Mobile Intel® Celeron® Processor on .13 Micron Process in Micro-FCPGA Package

Specification Update

October 2005

Document Number: 251309-028

Figure 12. System Bus Reset and Configuration Timings

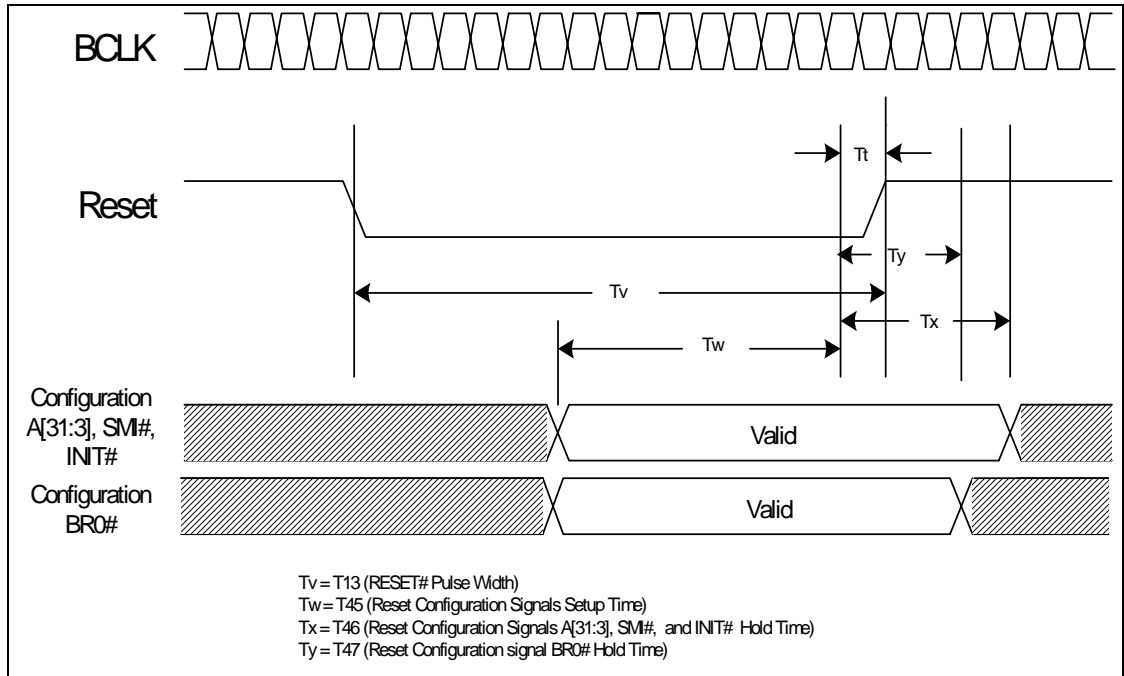
V2. BR0# Maximum Hold Time Specification Change

The BR0# maximum hold time has changed to 2 BCLKs. This change will be shown in the “System Bus AC Specifications (Reset Conditions)” table and “System Bus Reset and Configuration Timings” figure of the *Mobile Intel® Celeron® Processor on .13 Micron Process in Micro-FCPGA Package Datasheet*. This change will be incorporated in the next revision of the datasheet.

The following figure will be modified to reflect this change:

T# Parameter	Min	Max	Unit	Figure	Notes
T45: Reset Configuration Signals (A[31:3]#, BR0# INIT#, SMI#) Setup Time	4		BCLKs	13	1
T46: Reset Configuration Signals (A[31:3]#, INIT#, SMI#) Hold Time	2	20	BCLKs	13	2
T47: Reset Configuration Signal BR0# Hold Time	2	2	BCLKs	13	2

1. Before the deassertion of RESET#.
2. After clock that deasserts RESET#.
